October 27, 2021

SUBJECT: **Site Investigation – Additional Actions Required**  
(1) Review of Isoconcentration Maps and Cross-Section Figures  
(2) Potable Well Sampling Results from the Expanded Site Investigation Area  
JCI/Tyco FTC PFAS, 2700 Industrial Parkway South, Marinette, WI  
BRRTS #02-38-580694

## Attachment B – DNR Review of Isoconcentration Maps and Cross-Section Figures

### Figure 3

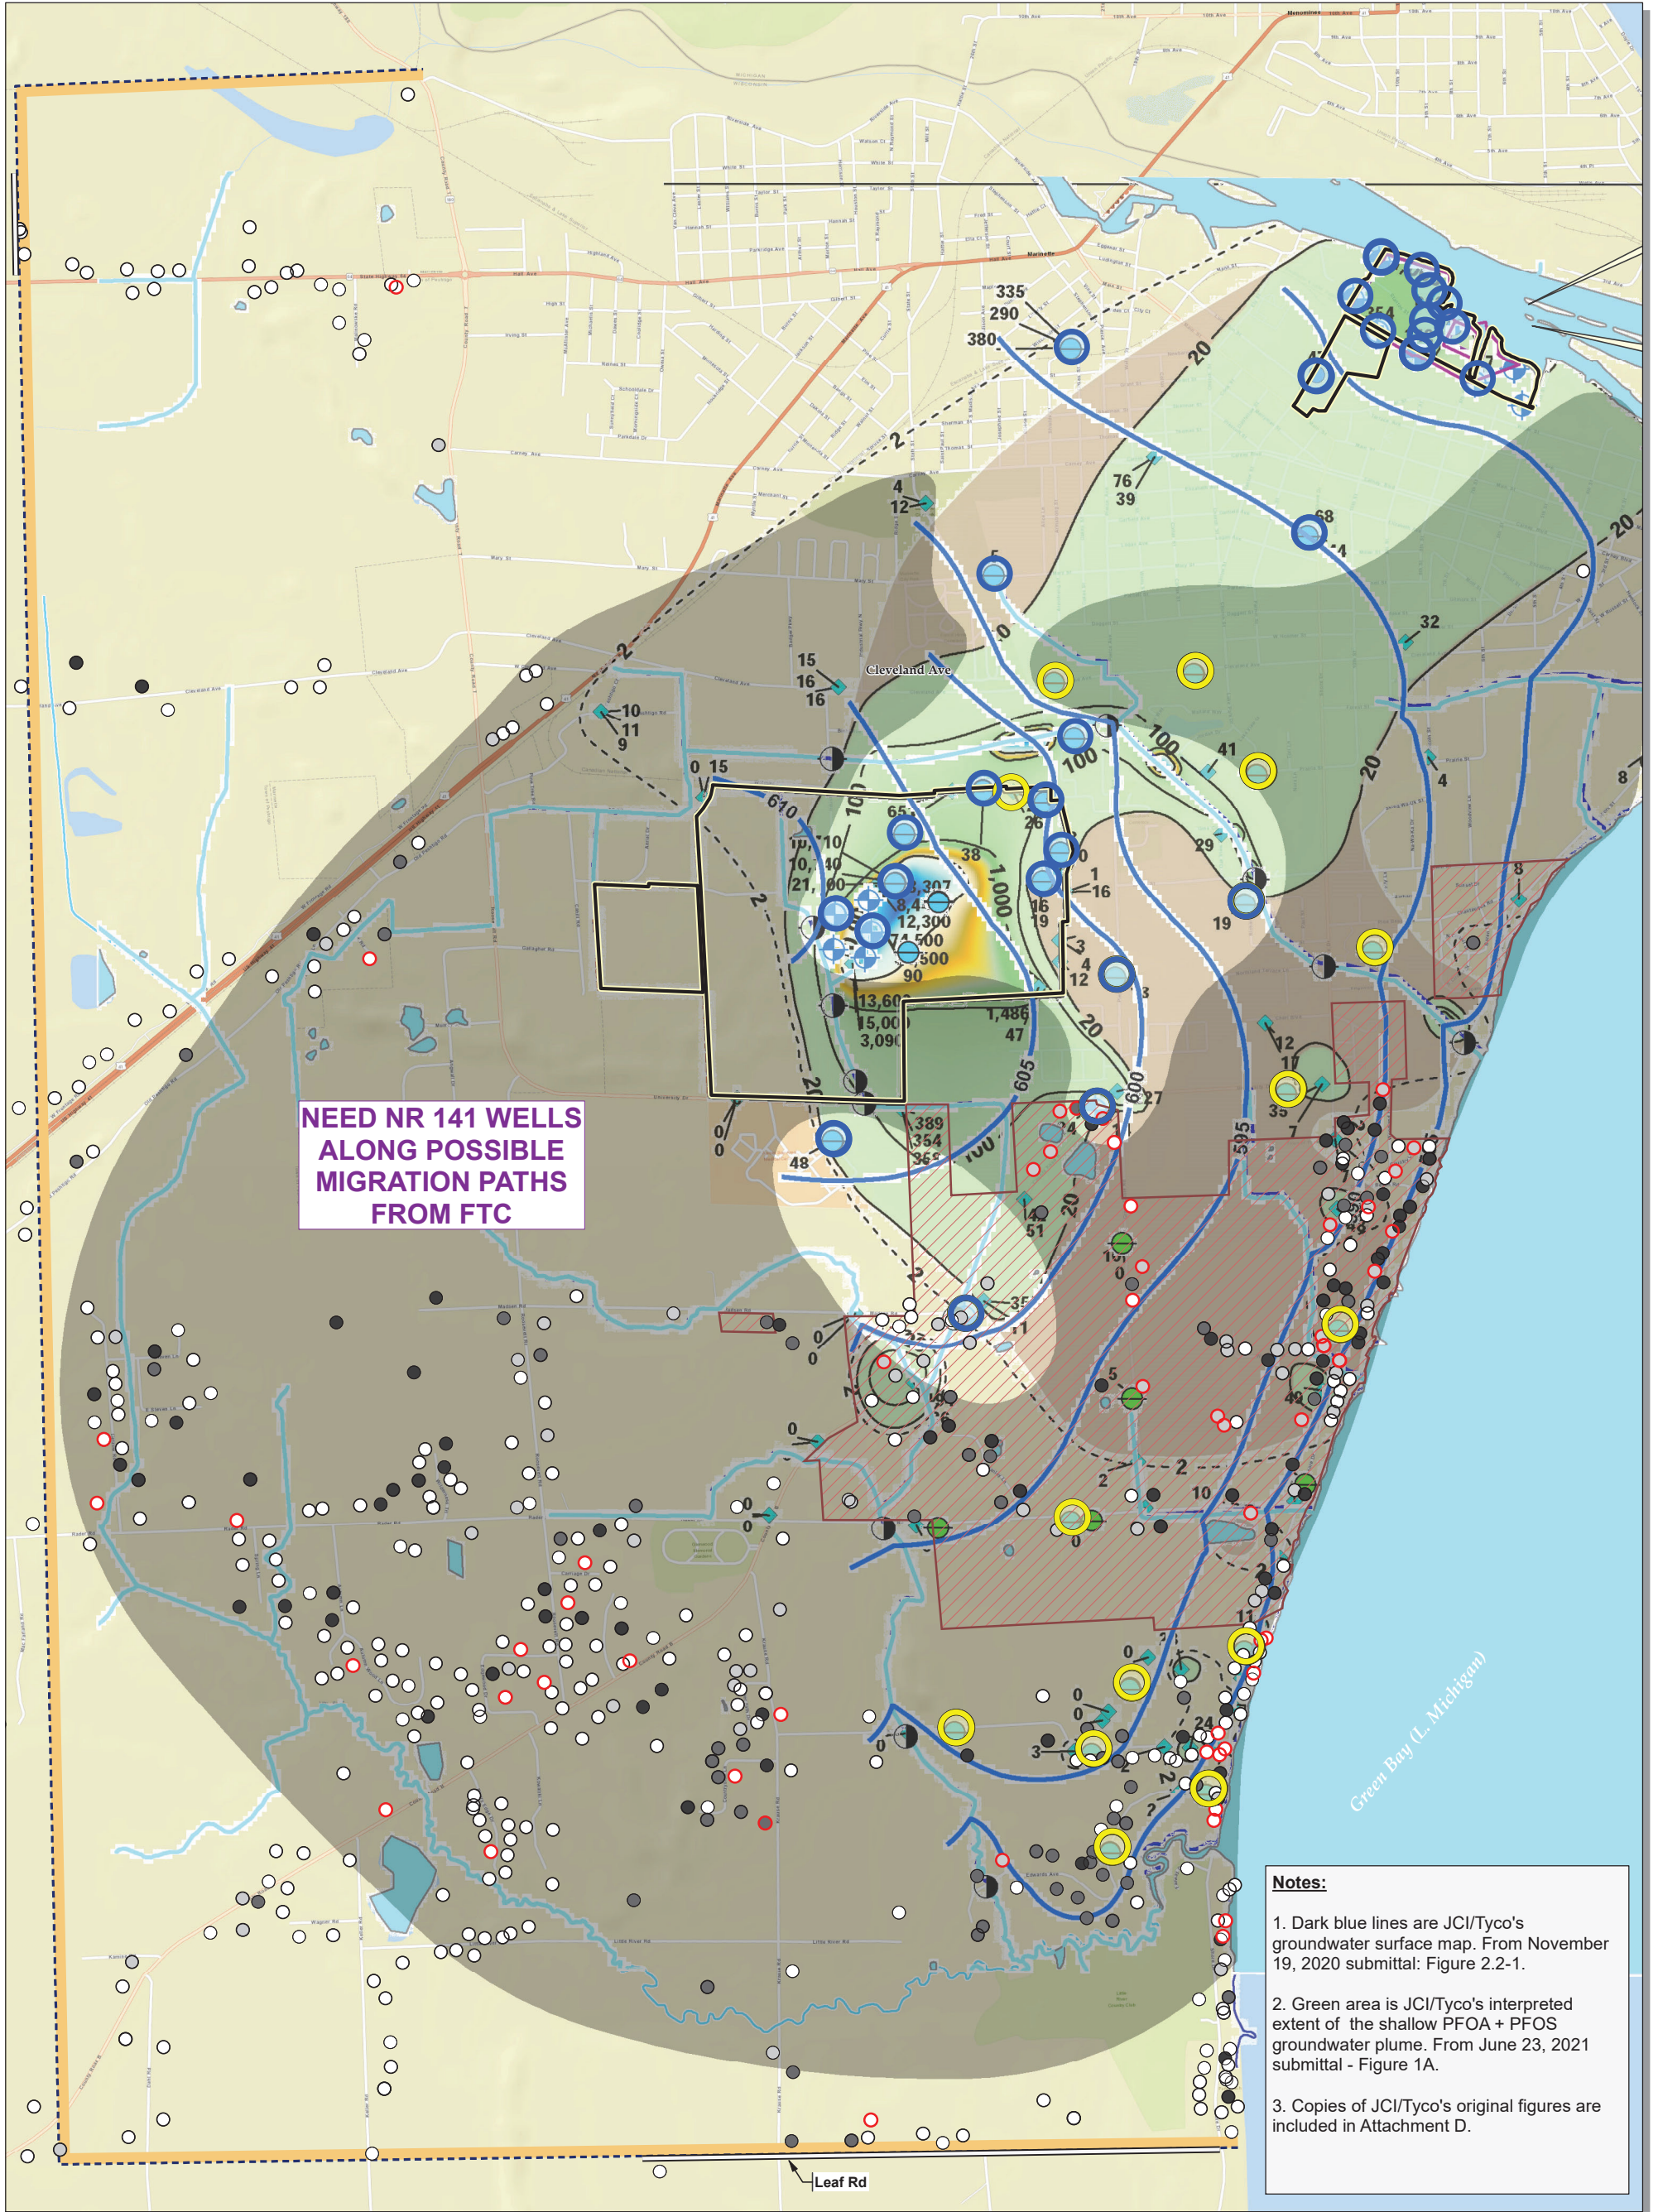
To illustrate this deficiency in the groundwater investigation, the DNR overlaid JCI/Tyco's shallow isoconcentration and shallow groundwater potentiometric surface maps (with NR 141 wells) onto the DNR's Figure 1 with the potable well testing results. This overlay is presented in **Figure 3** and highlights the following:

- (1) areas where NR 141 wells were installed, but which have not been tested for PFAS (these wells are also summarized in **Attachment C**), and
- (2) areas lacking NR 141 wells needed for PFAS testing data and/or water level measurements to substantiate isoconcentration maps and cross sections.

### Cross-Section A-A'

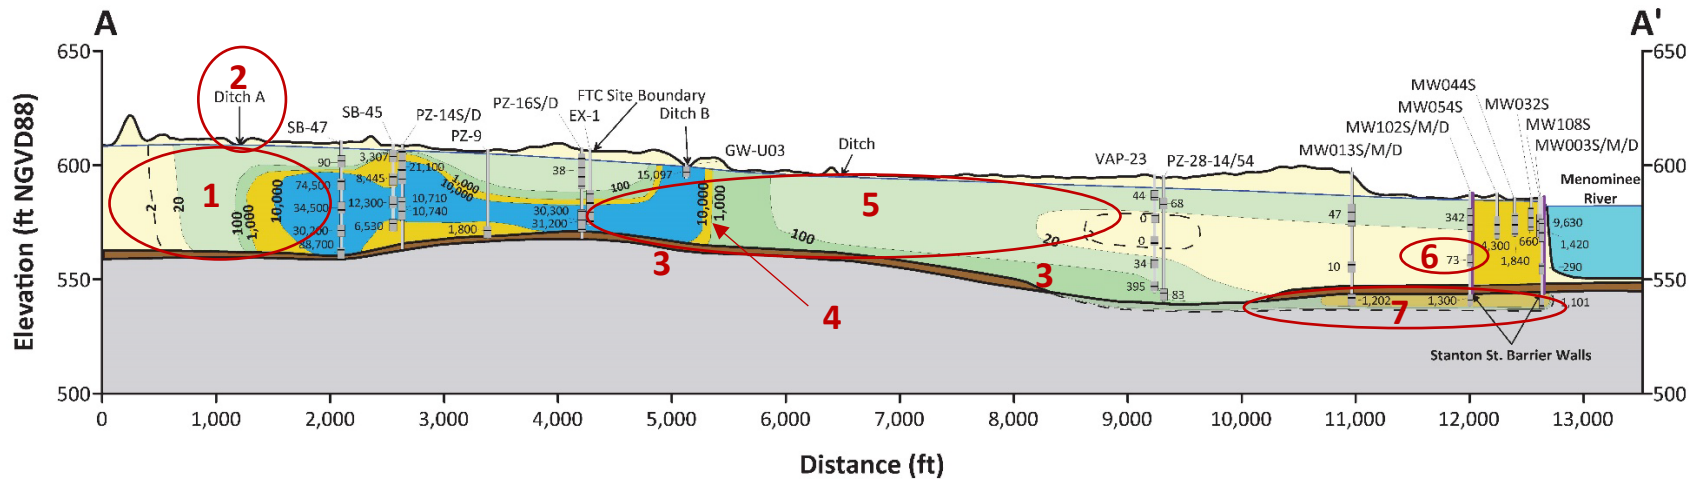
1	No data west of SB-45 and SB-47 to define extent of contamination.
2	How do the PFAS detected in surface water in Ditch A relate to groundwater plume?
3	No data to evaluate migration pathways along weathered bedrock or to evaluate presence of till.
4	How can such a steep concentration gradient be explained here? In JCI/Tyco's January 12, 2021 letter it states, "Ditch B is predominantly gaining but is not a complete groundwater discharge boundary... Ditch B is interpreted to intercept portions of overburden groundwater flow, while some deeper groundwater migrates underneath."
5	No Data between EX -1 and PZ-28 (~ 1 mile) – except for shallow groundwater at Ditch B
6	Why is this detection of PFAS > 20 ppt not included in the 20 ppt contour interval?
7a	Why is the 1,000 ppt in shallow bedrock not connected to plume coming from the FTC? If Stanton Street is the assumed source of these detections of PFAS, then please provide corresponding arsenic data to support this argument.

7b	If the three wells (MW003D, MW013D and MW102D) screened in the shallow weathered bedrock have concentrations of PFAS > 1,000 ppt, what is the basis for assigning this as zero-concentration boundary across the rest of the site? The weathered bedrock layer and fractures or other more permeable sections of bedrock must be evaluated as potential migration pathways (Wis. Adm. Code § NR 716.11(5)(a)).

### Cross Section B-B'

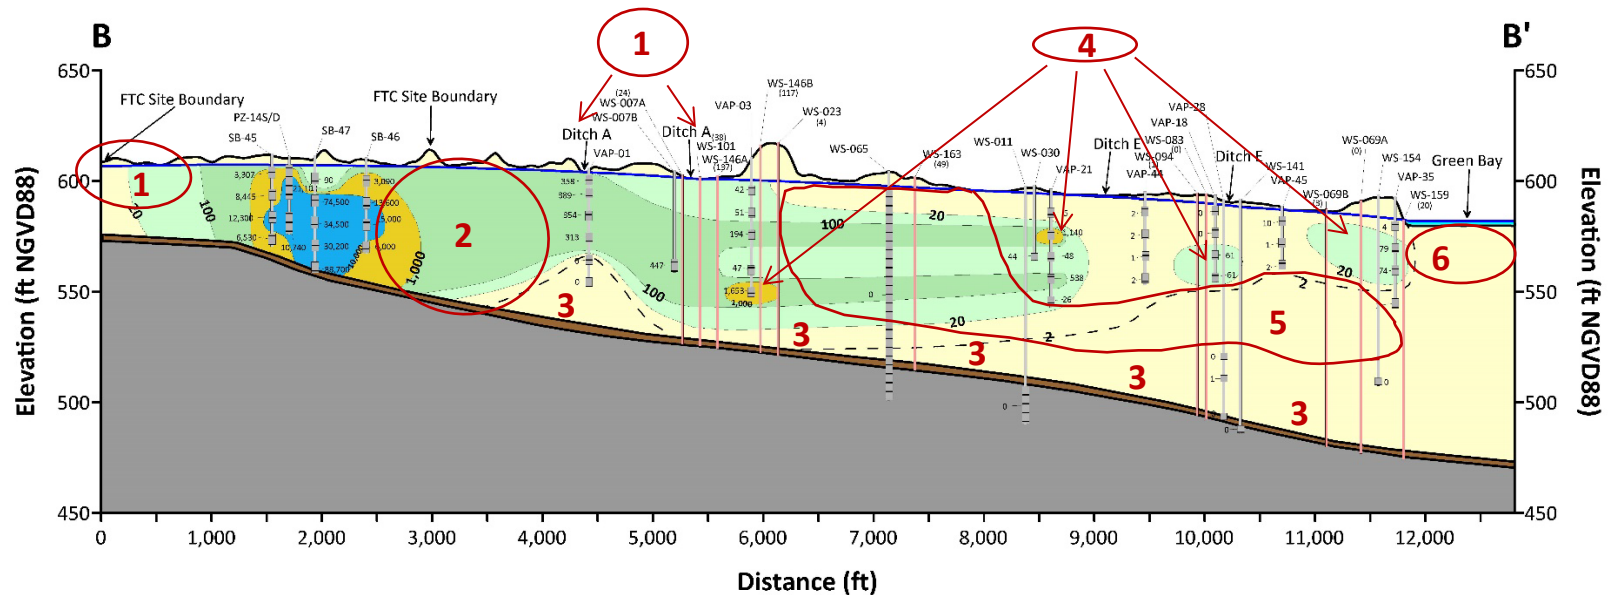
1	How do the PFAS detected in surface water in Ditch A relate to the groundwater plume?
2	No data to define extent of contamination near source area.
3	No data to evaluate migration along weathered bedrock or to evaluate presence of till.
4	Why are these points disconnected from the similar concentration areas in the upgradient plume? Were localized migration paths considered (i.e., is not more likely that these detections in the downgradient plume are connected by preferential flow paths to areas of similar concentration in the upgradient plume)?
5	Limited data to define extent of contamination and evaluate migration through possible preferential flow pathways.
6	Is the groundwater plume discharging into Green Bay? What is the basis for ending the contaminant plume at Green Bay?

### Cross Section C-C'

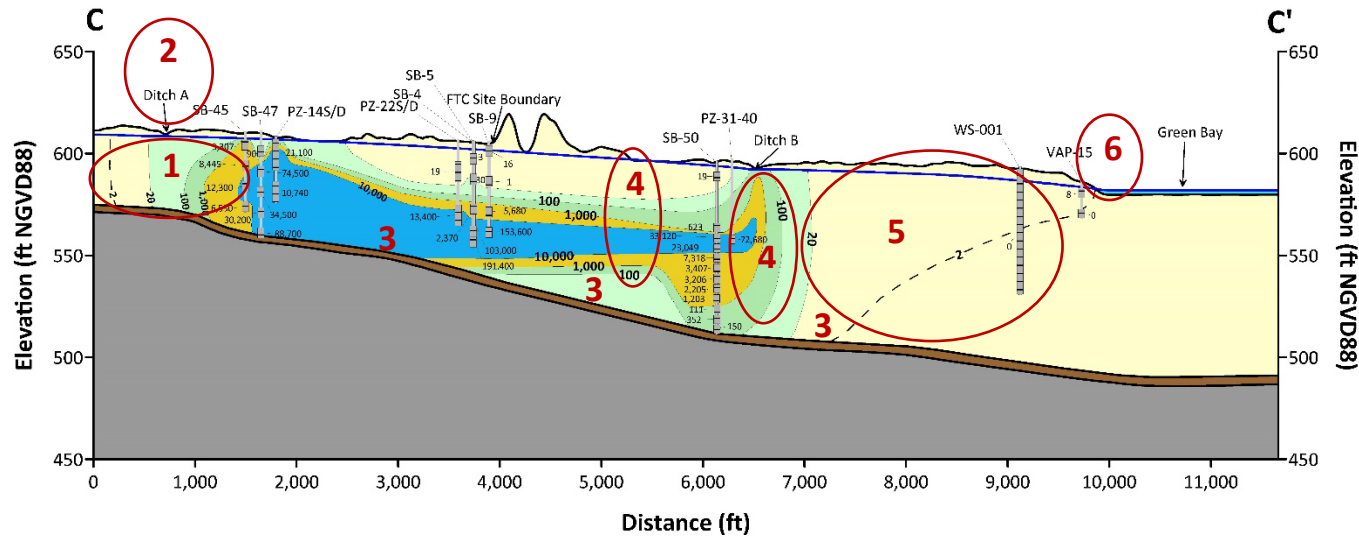
1	No data west of SB-45 and SB-47 to define extent of contamination.
2	How do the surface water concentrations > 1,000 ppt measured in Ditch A relate to groundwater plume?
3	No data to evaluate migration along weather bedrock or to evaluate presence of till.
4	No data to define the vertical extent of groundwater contamination around where PFAS > 10,000 ppt.
5	No data to define extent of contamination (~ ½-mile).
6	How do the PFAS in surface water detected in (nearby) Ditch C relate to groundwater plume?

### Cross-Section D-D'

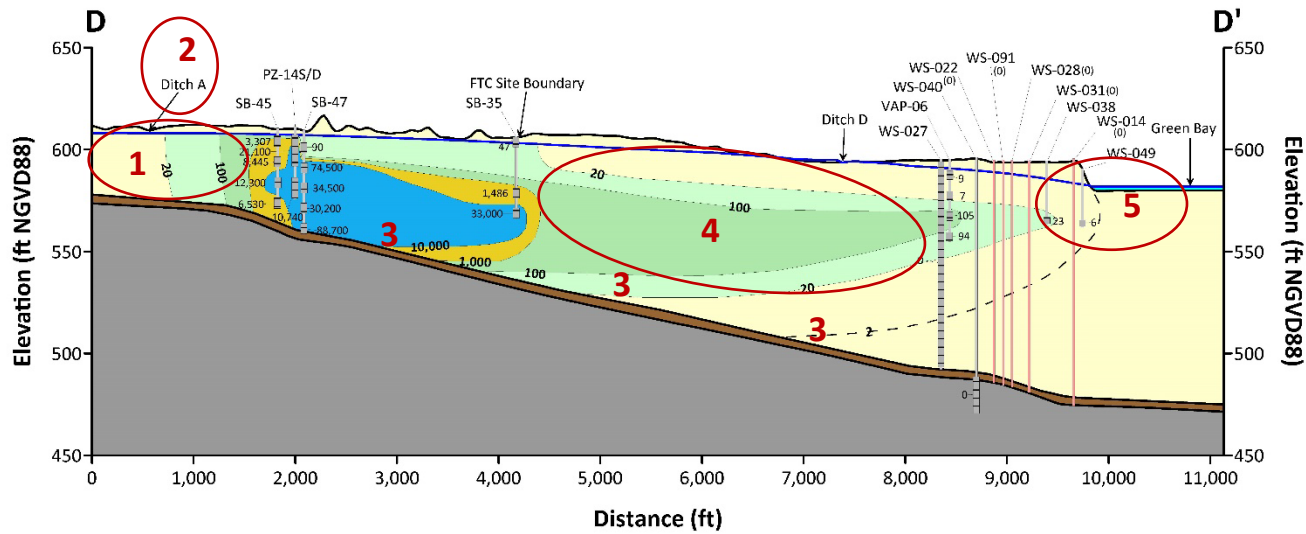
1	No data west of SB-45 and SB-47 to define extent of contamination.
2	How do the PFAS detected in surface water in Ditch A relate to groundwater plume?
3	No data to evaluate migration along weather bedrock or to evaluate presence of till.
4	No data to define extent of contamination (~ 1-mile).
5	Is the groundwater plume discharging into Green Bay? What is the basis for ending the contaminant plume at Green Bay?

### Cross-Section E-E'

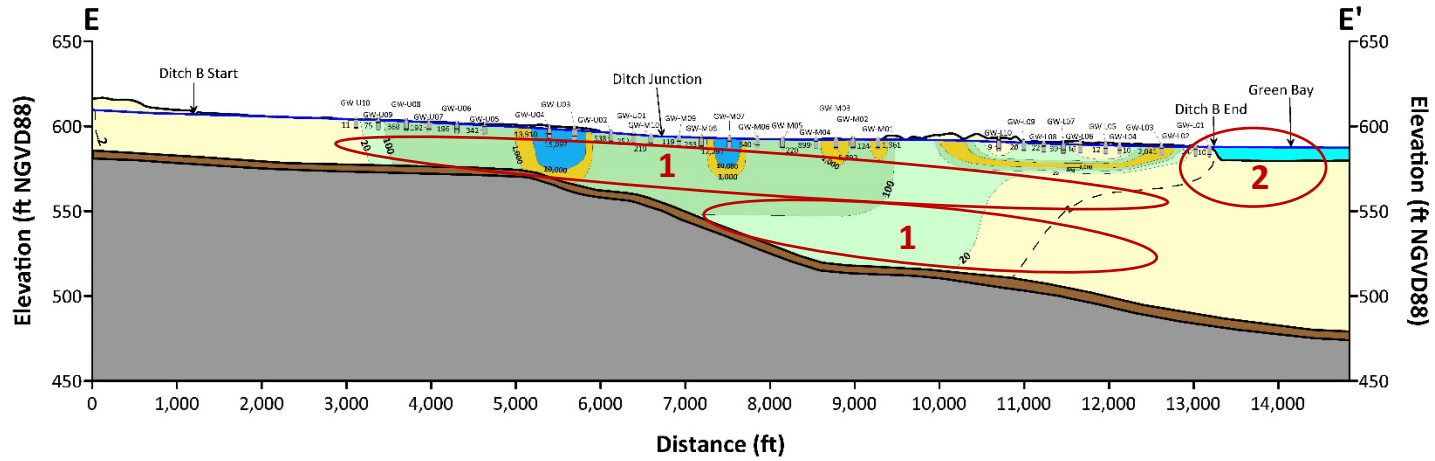
1	No data to define the vertical extent of groundwater contamination below Ditch B.
2	If PFAS is detected in deeper sections of the aquifer below Ditch B, does it discharge into Green Bay?

## Shallow GW Plume Map (Figure 1A)

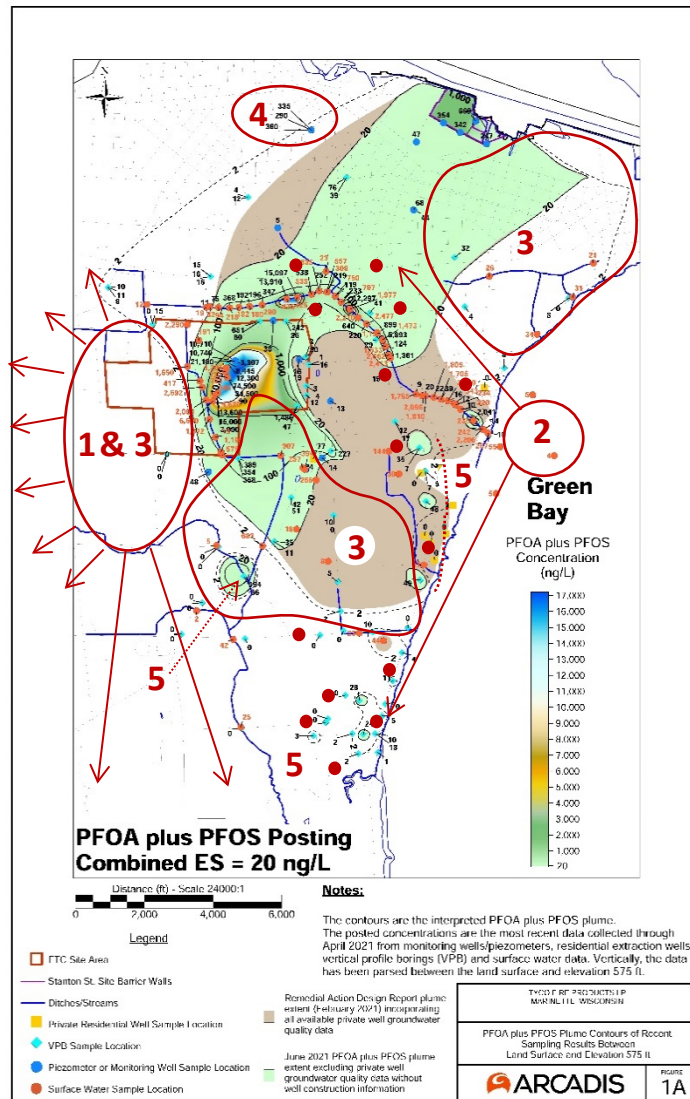
- 1 - No data west of Ditch A to define extent of contamination  
*The current isoconcentrations maps assume that all the PFAS discharged at the FTC Site entered the groundwater near the Outdoor Testing Area (OTA); however, it is possible that one or more migration pathways transported PFAS west or south along Ditch A.*

- 2 – Need to sample existing NR 141 wells for PFAS.  
*The red dots highlighted on this map represent wells JCI/Tyco constructed off the FTC property not tested for PFAS.*

- 3 – Need to install NR 141 wells to characterize PFAS in these areas,  
*Field investigation must be completed to document the degree and extent of contamination in these areas and sampling points must be selected to test all possible migration pathways.*

- Questions on current interpretation
- 4 – Why is this data not included in the isoconcentrations contour?
- 5 - Why are the areas near “5” disconnected from the upgradient plume? Were preferential flow paths evaluated or considered?
